HISTORIC AND DESIGN REVIEW COMMISSION

September 04, 2019

HDRC CASE NO: 2019-502
ADDRESS: 1323 FULTON AVE
LEGAL DESCRIPTION: NCB 2754 BLK 60 LOT 19 & W 25 FT OF 20
ZONING: R-4,H
CITY COUNCIL DIST.: 1
DISTRICT: Fulton Historic District
TYPE OF WORK: Window replacement, Historic Tax Certification
APPLICATION RECEIVED: August 16, 2019
60-DAY REVIEW: October 15, 2019
CASE MANAGER: Stephanie Phillips

Window Damage
1323 Fulton Ave

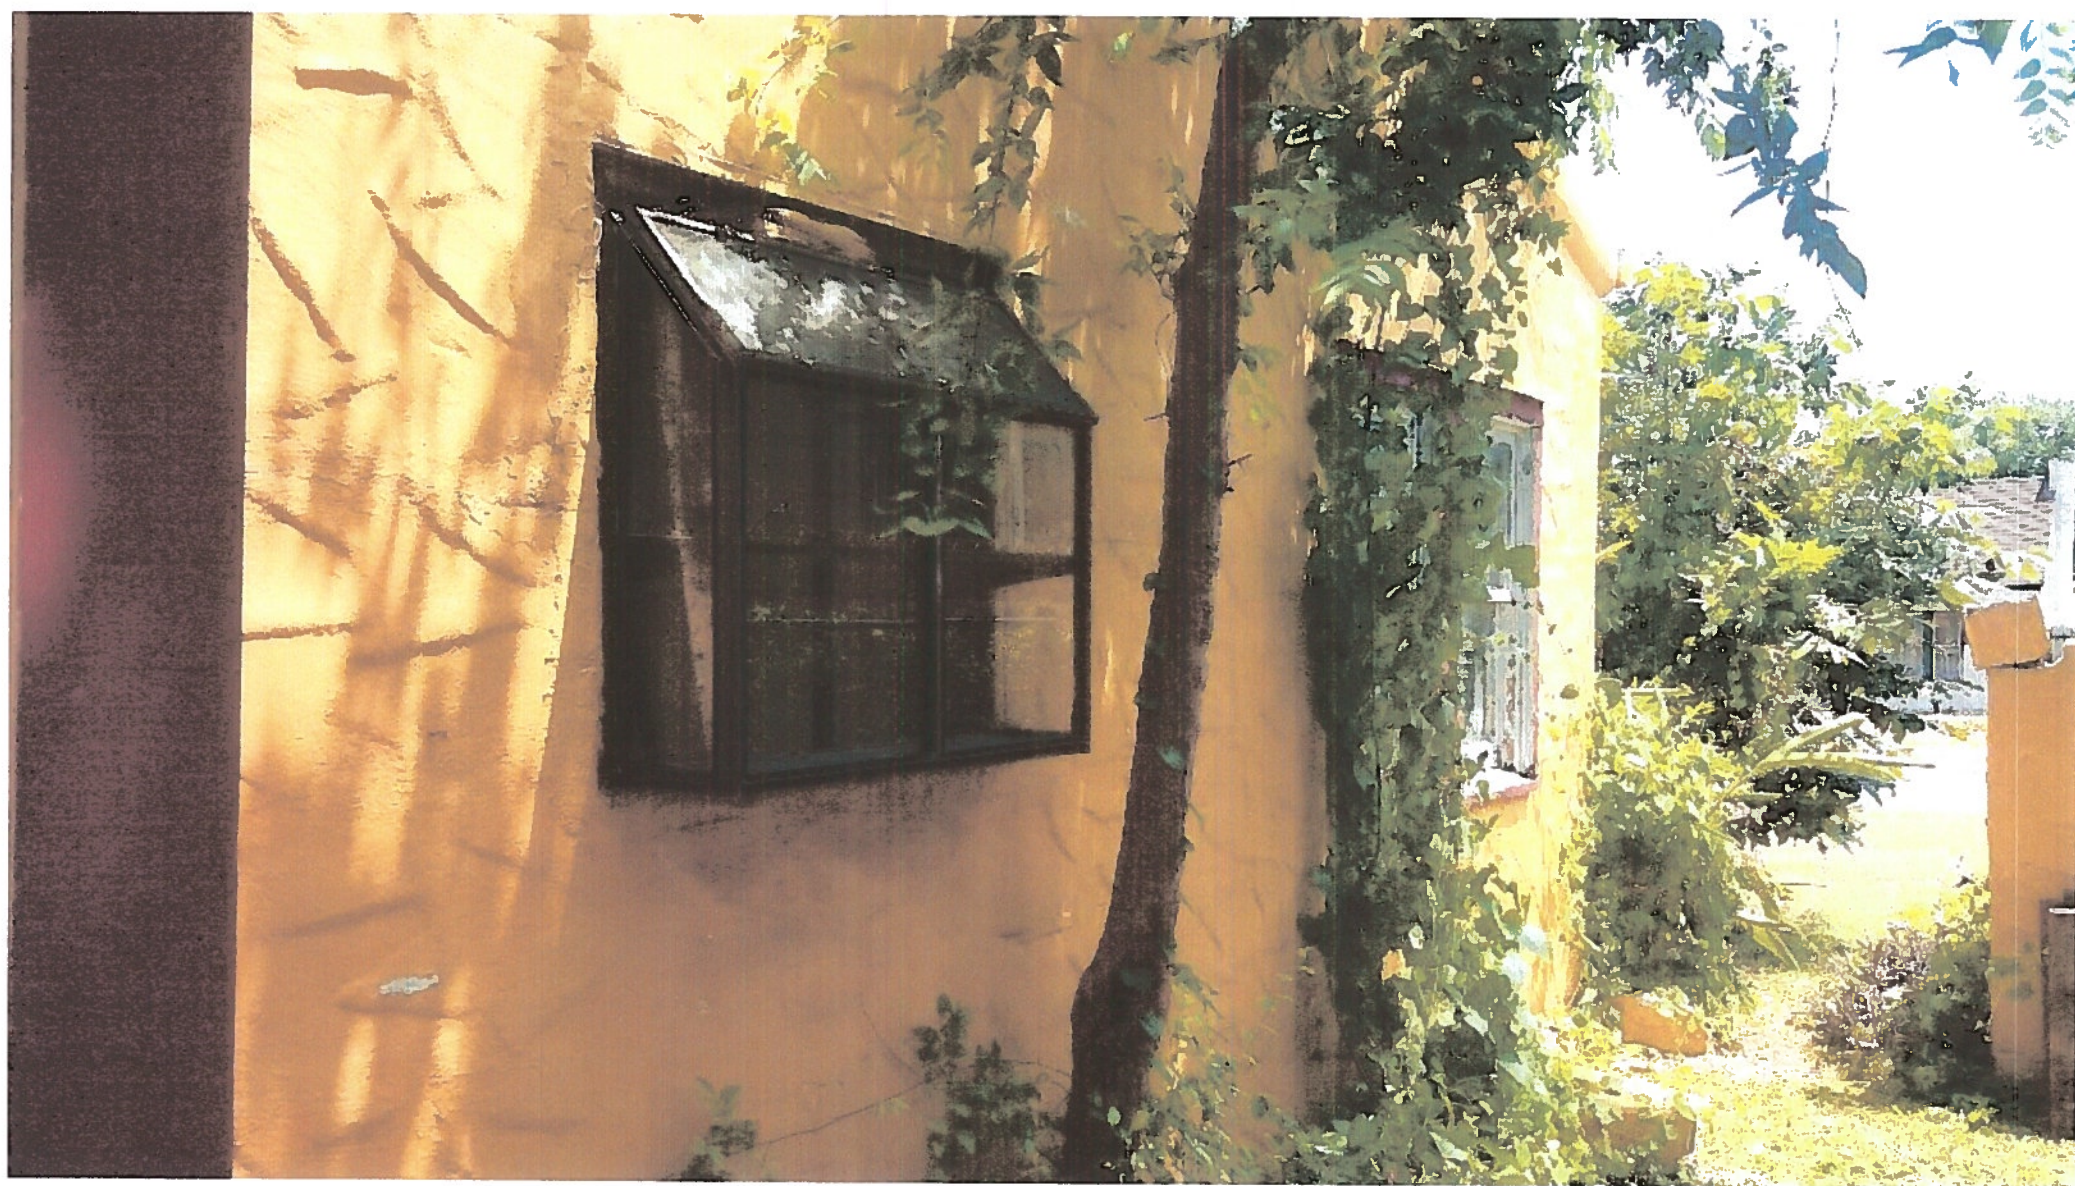
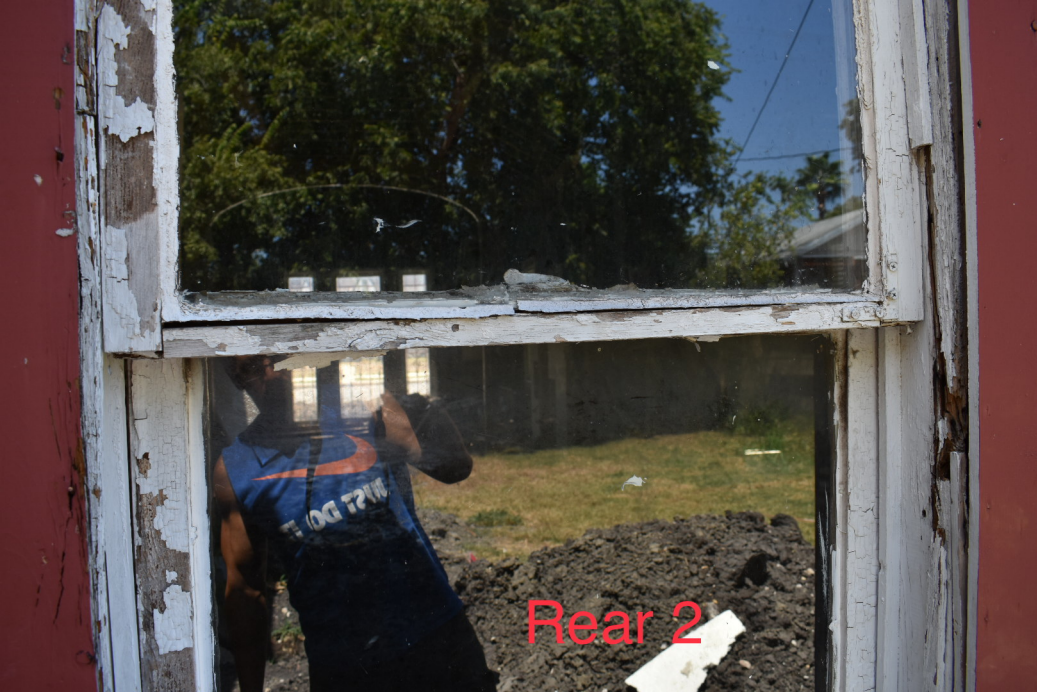
- b. EXISTING WINDOWS: CONDITION – The applicant provided several photographs of the existing windows taken from outside and inside the structure. Two windows are non-original vinyl; one window is a non-original aluminum bay-style window; and three are non-original wood windows. The remaining appear to be original wood windows. Based on the photographic evidence provided, staff finds that the original wood windows have been subject to severe deterioration. Most feature slipping joints, extensive dry rot in both the stiles and rails, and some feature missing or completely separated lower rails. Based on the evidence provided, staff finds the windows to be eligible for replacement.

- c. WINDOW REPLACEMENT – According to the Guidelines for Exterior Maintenance and Alterations 6.A.iii., and 6.B.iv., in kind replacement of windows is only appropriate when the original windows are beyond repair. Based on finding b, staff finds the original windows to be deteriorated beyond repair, and finds that the non-original windows are eligible for replacement. As of August 30, 2019, the applicant stated his intent to replace the windows with a new fully wood product to match the existing in style, configuration, proportion, inset, profile, and dimensions as closely as possible. Staff finds the request appropriate based on the property-specific conditions.

Item 1, Staff recommends approval of the window replacement based on findings b and c with the following stipulation:

- i. That the applicant installs one-over-one fully wood windows to match the existing configuration as closely as possible. Meeting rails must be no taller than 1.25" and stiles no wider than 2.25". There should be a minimum of two inches in depth between the front face of the window trim and the front face of the top window sash. This must be accomplished by recessing the window sufficiently within the opening or with the installation of additional window trim to add thickness. The final specification should be submitted to staff for review prior to the issuance of a Certificate of Appropriateness.
